METROPOLITAN GOVERNMENT OF NASHVILLE AND DAVIDSON COUNTY

STAFF RECOMMENDATION
2405 Belmont Boulevard
February 18, 2015

Application: New construction-addition; Partial demolition
District: Belmont-Hillsboro Neighborhood Conservation Zoning Overlay
Council District: 18
Map and Parcel Number: 10416029500
Applicant: Manuel Zeitlin, architect
Project Lead: Melissa Baldock, melissa.baldock@nashville.gov

<p>Description of Project: Applicant proposes a two-story addition on an existing contributing house.</p> <p>Recommendation Summary: Staff recommends approval with the conditions that the applicant seek final approval of all materials. With this condition, the project meets the design guidelines for the Belmont-Hillsboro Neighborhood Conservation Zoning Overlay.</p>	<p>Attachments A: Site Plan B: Elevations</p>
--	--

Figure 1: Rear of home. Outbuilding seen on the left has been removed.

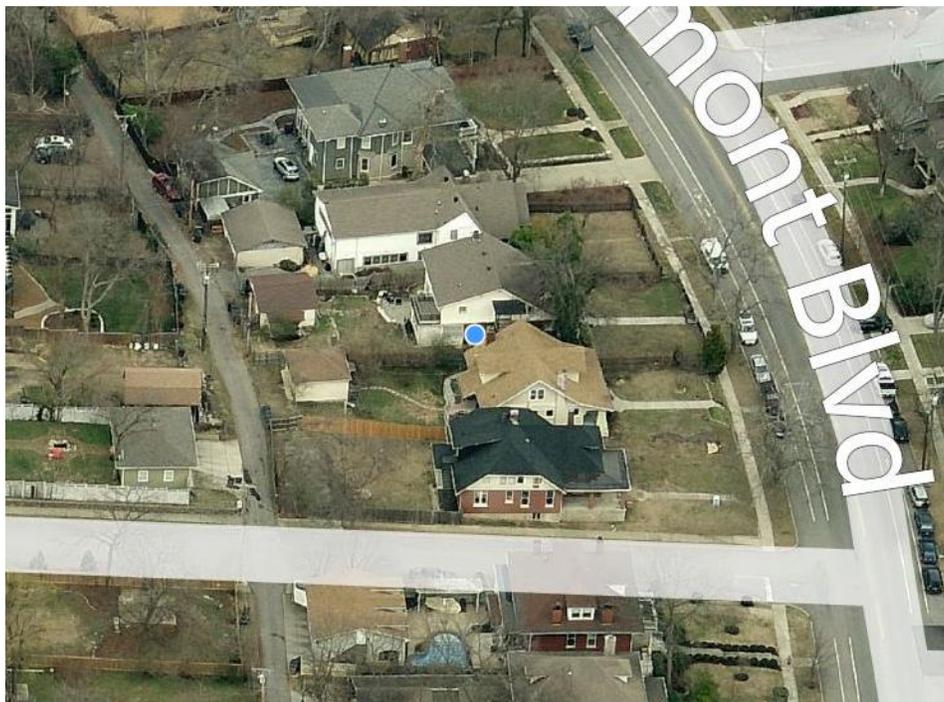
Location & Removability: The proposed addition is located to the rear of the building. It includes a second level on the left side over an existing one-story addition that will be essentially flush (with the exception of the change in material) with existing side wall. On the right, the addition will be two-stories, also proposed to be flush with the existing wall.

E, N ELEVATIONS
MHZC REVISED
PROPOSAL
1-07-15

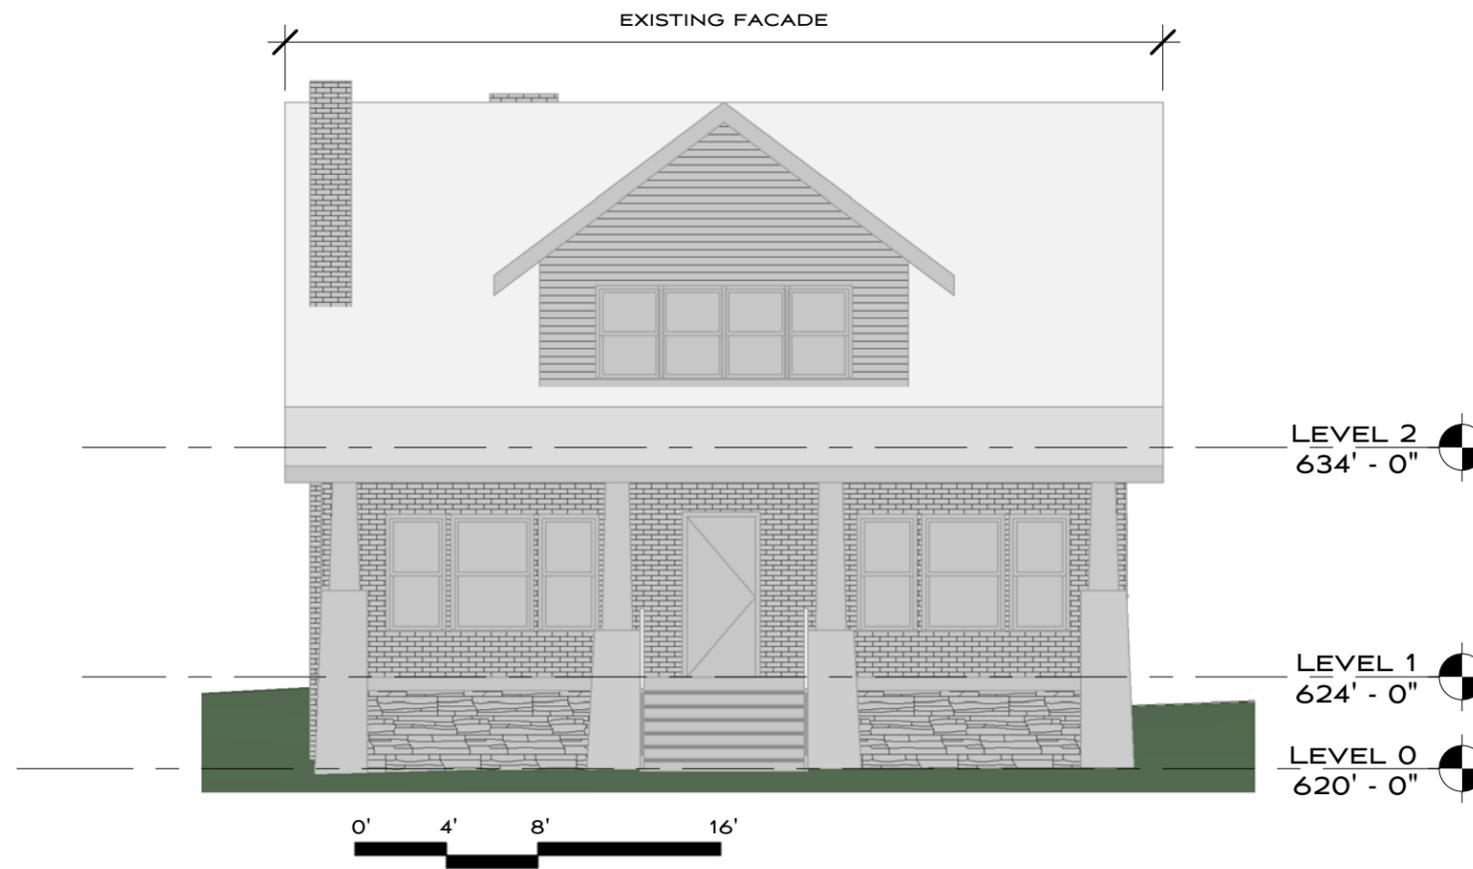
According to the design guidelines, two-story additions should sit in a minimum of two-feet (2') to help distinguish from the new from the old and to lessen the impact of the mass of the addition on the existing house. Since the left side of the addition is over an existing portion of the house, no inset is recommended. In July 2012, the Commission determined under a different, but similar design, that no inset was needed on the right elevation because the change in roof form and the change in materials achieved the effect

of differentiating the historic house from the addition. Based on that decision, staff finds that like the former design, the current design shows a break in roof form and change of materials, and therefore no inset should be required on the right elevation. In addition, staff finds that the addition could be removed in the future without substantially altering the historic integrity of the house.

Height & Scale: The foundation line is above the existing foundation due to the rise in grade from the front of the lot to the back. The addition does not exceed the height or width of the existing building; however, the eave heights are tall to accommodate a full two-stories behind this one and one-half story home. Staff finds the height and scale to meet sections IIB.a and b. and II.B.2.a. of the design guidelines.

Roof Shape: The roof is a deconstructed gable roof. It does not match the existing roof form but gable roofs are typical of historic additions and this one will have minimal visibility from the street and will not interfere with the existing roof form. The addition is two-stories on a one and one-half story home, so the eave lines do not match the existing. Staff finds the roof shape to be appropriate for the district and to meet section II.B.e and II.B.2.a.

Proportion and Rhythm of Openings: The new windows are in alignment with existing windows and of the same proportion. The rhythm of openings is similar to that found on the existing building. Staff finds the rhythm of openings and the proportion of openings to be appropriate and meet Section II.B.g.

Staff recommends approval with the conditions that the applicant seek final approval of all materials. With this condition, the project meets the design guidelines for the Belmont-Hillsboro Neighborhood Conservation Zoning Overlay.

W, S ELEVATIONS
MHZC REVISED
PROPOSAL
1-07-15

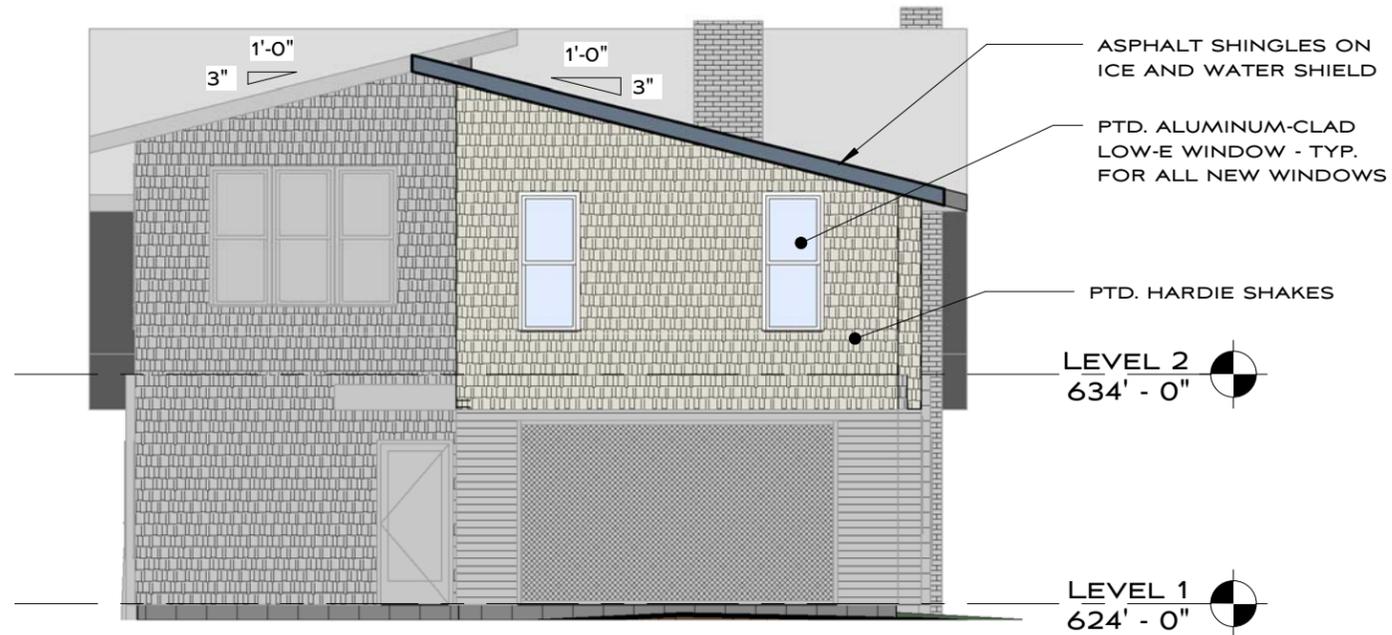
Materials, Texture, Details, and Material Color: The foundation material is unknown, the addition will be clad in cement fiber shingles and lap siding, and the roof material is asphalt shingle but the color is unknown. The chimney will be masonry but the exact material is unknown as are the design of the aluminum clad windows, doors, trim and rear railings. Final staff review of all materials is recommended.
